LIGHTS - LED LANDING/TAXI LIGHT INSTALLATION

To remove the incandescent or obsolete High-Intensity Discharge (HID) landing or taxi lights with new LED lights.

SEB-33-02
Page 1 of 7

Figure 1. Wiring Modifications (Sheet 1)

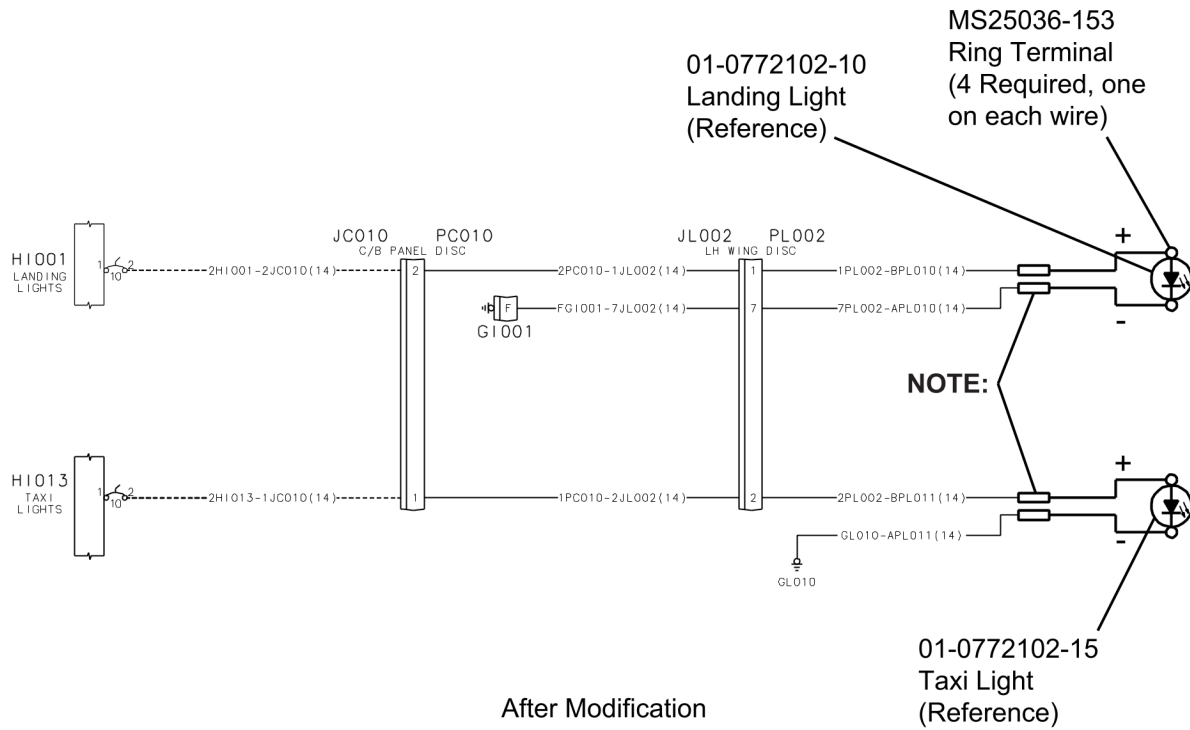
5. (Refer to Figure 1, Sheet 1 and 2.) Do the wiring modifications as follows:

- A. Cut the existing power and ground wiring connector that connected to each HID ballast.
- B. Temporarily place the 01-0772102-10 Landing Light into the light assembly bracket.

- C. Make sure that the cut wires from the existing HID ballast will reach the electrical connections of the 01-0772102-10 Landing Light.

(1) If the cut existing wires will not reach the electrical connections of the 01-0772102-10 Landing Light do as follows.

- (a) Splice additional M81044/12-14-9 Unmarked Electrical Wiring as required onto each cut electrical wire with one M81824/1-3 Splice.

- D. Install one MS25036-153 Ring Terminal to the end of each electrical wire.

NOTE: The electrical wire labeled BPL010 for landing light and BPL011 for taxi light should be connected to the positive terminal of the respective LED lamp assembly.

NOTE: Install the M81824/1-3 Splice and M81044/12-14-9 Unmarked Electrical Wiring as required to extend the existing wiring to the 01-0772102-10 Landing Light and the 01-0772102-15 Taxi Light .
